From: Kerry Nash - KN Planning
Sent: 17/08/2022 6:24:32 PM
To: [REDACTED] Council Northernbeaches
Mailbox
Cc: James Lloyd
Subject: Objection to DA2022-1164 re 34-35 South Steyne Manly on behalf of S
Dawson
Attachments: KN59003 Objection re DA2022-1164 34-35 South Steyne Manly
Dawson 17.08.22.pdf;

Ref: KN590/03

**Re: Development Application No DA2022/1164
34-35 South Steyne Manly
Objection to proposed development**

Figure 2

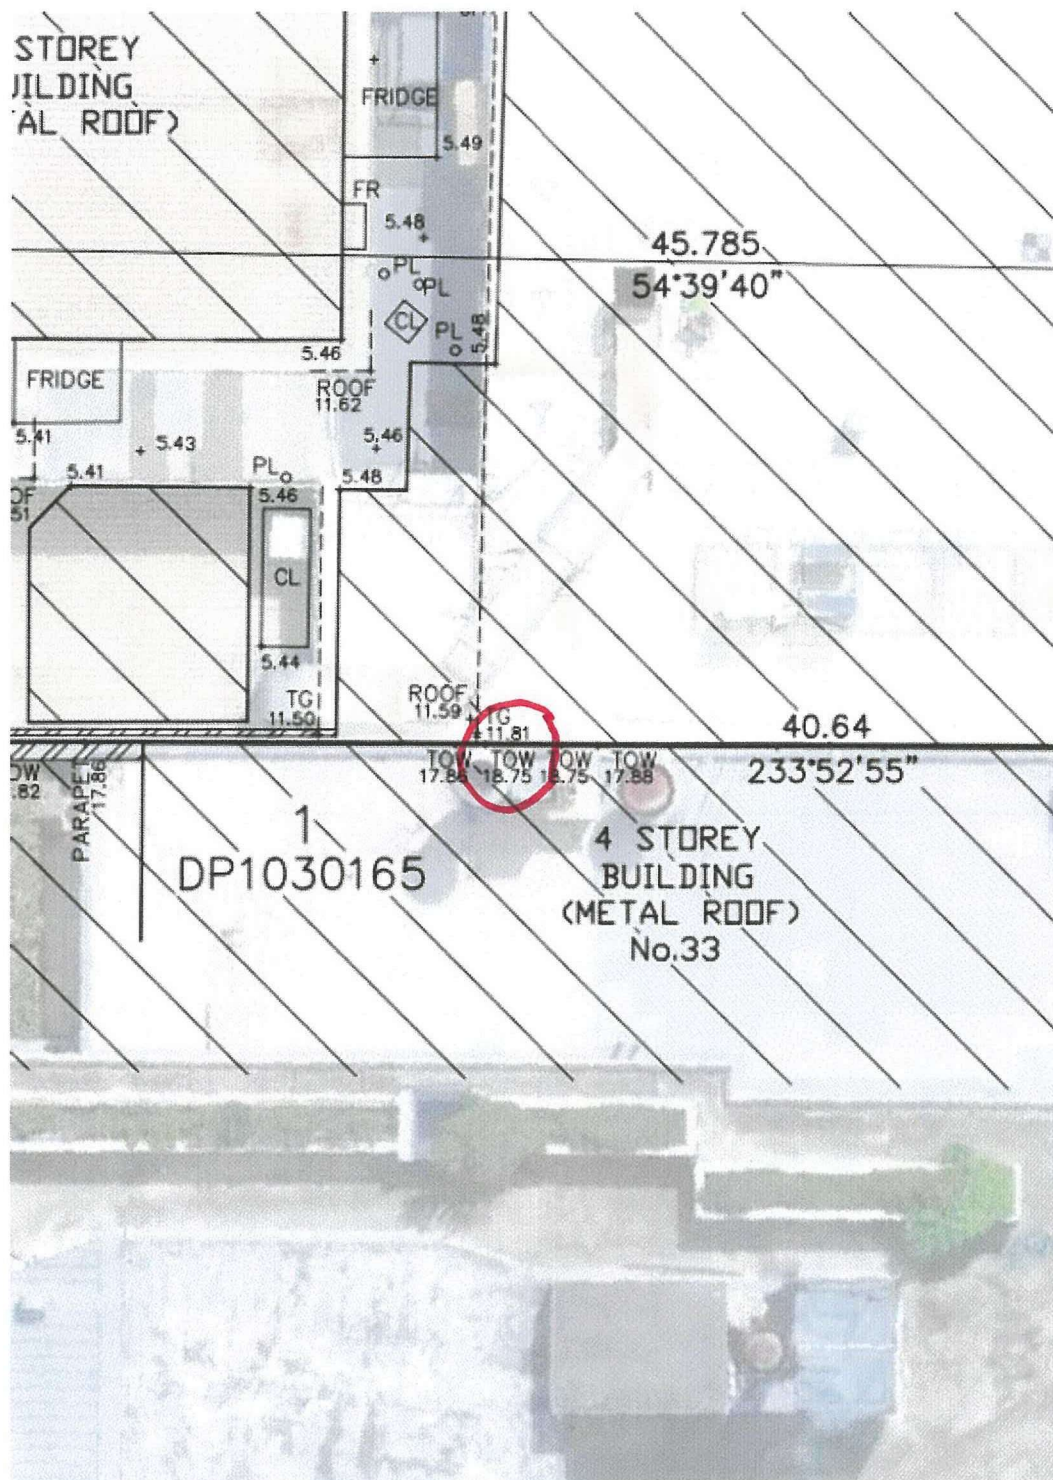
Balcony – loss of land and water interface with Manly Beach at high and low tide and the lower portions of Norfolk Island Pines along South Steyne (*Photograph 4*). The assessment of view loss is relatively accurate as the lift overrun on the adjoining building (33 South Steyne) has a surveyed height of RL18.75 which is 25cm lower than the proposed rear roof line and generally in line with the eastern façade of the proposed upper level (RL19.00), as evidenced by the extract from the Plan of Survey at *Figure 2*.

The extent of non-compliance is substantial – the 12-metre height standard at the rear portion of the site is at RL17.00; the proposed building height for the rear portion of the development is RL19.00 with the lift overrun height above the upper roof level not indicated on the drawings.
